SERVICE LETTER 216

Cessna 208 Caravan 8000A & 8750A Hydraulic Pump Replacement

Aircraft Makes/Model(s):	Float Model(s):	Compliance: Optional	By: MAS
Textron Aviation 208	8000A & 8750A	Part Number: 1011602	Approved: DRH
		Date: 4/11/2023	Revision: B

NEW
HYDRAULIC PUMP 1011404

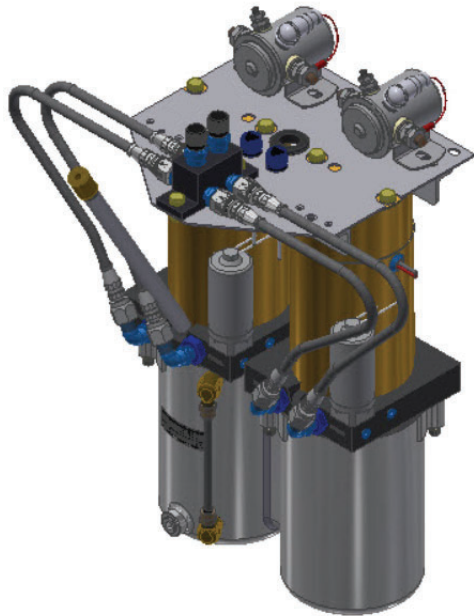
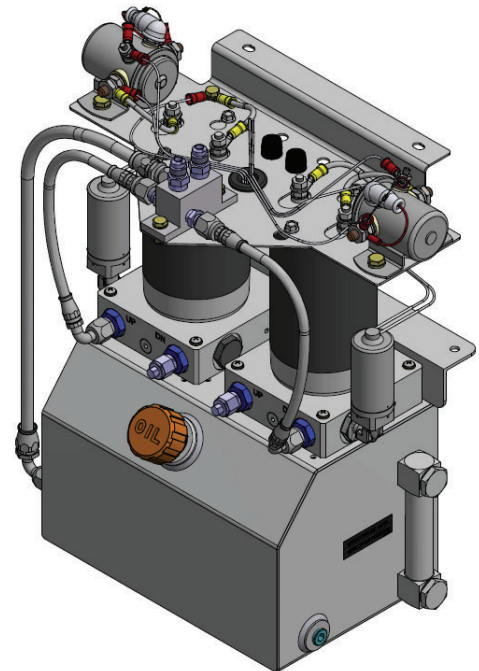
Hydraulic Pump Assembly p/n 8A09000-031 has been discontinued. This service letter provides the option to replace it with a new pump p/n 1011404.

SOLENOID SCHEMATIC

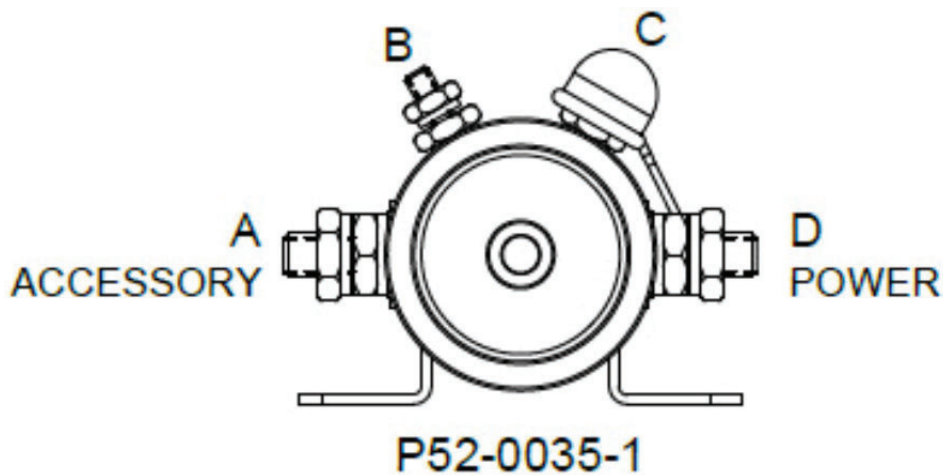
1. Pull Pump 1 and Pump 2 circuit breakers.
2. Remove and cap both pressure and return hydraulic lines on hydraulic pump manifold 6A09000-027.
3. Remove GA1 and GA4 wires (12 ga) from electrical solenoids on hydraulic power pack 8A09000-031.

HYDRAULIC SCHEMATIC

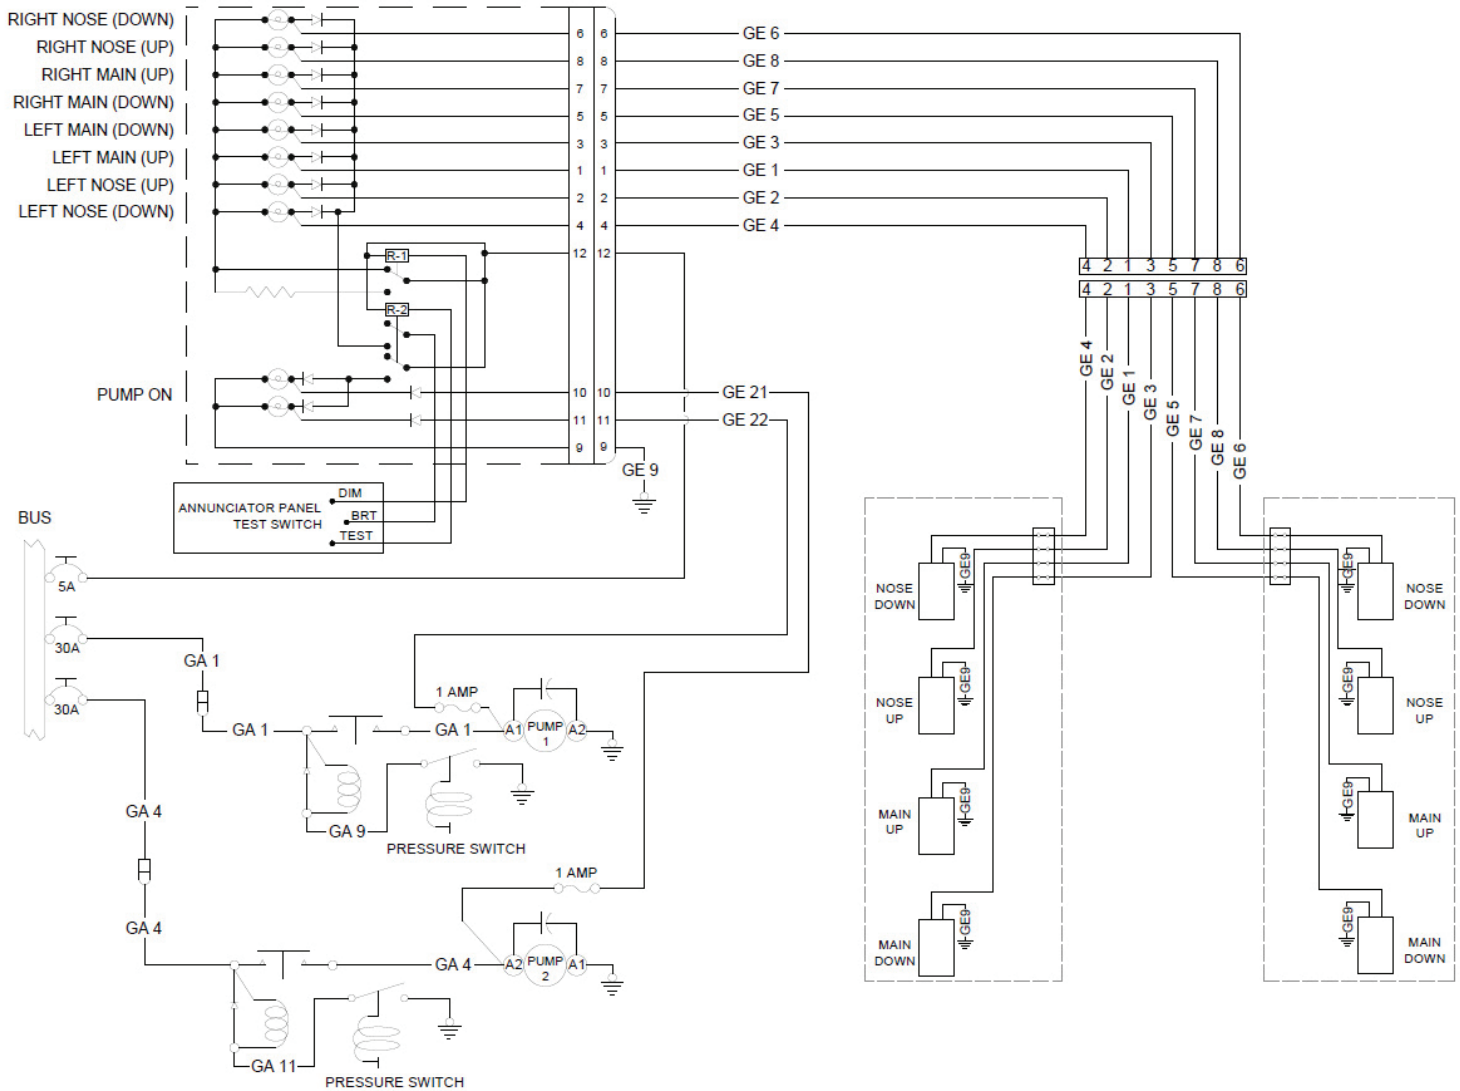
4. Cut GE10 and GE11 wires (20 ga) at butt splice connection. If aircraft has G1000 avionics, cut GE21 and GE22 (20 ga) wires.
5. Unbolt and remove hydraulic power pack 8A09000-031 from pump mount assembly.
6. Install new hydraulic power pack 1011404 onto pump mount assembly using existing hardware.
7. Install pressure and return line to hydraulic pump manifold. Refer to hydraulic schematic.
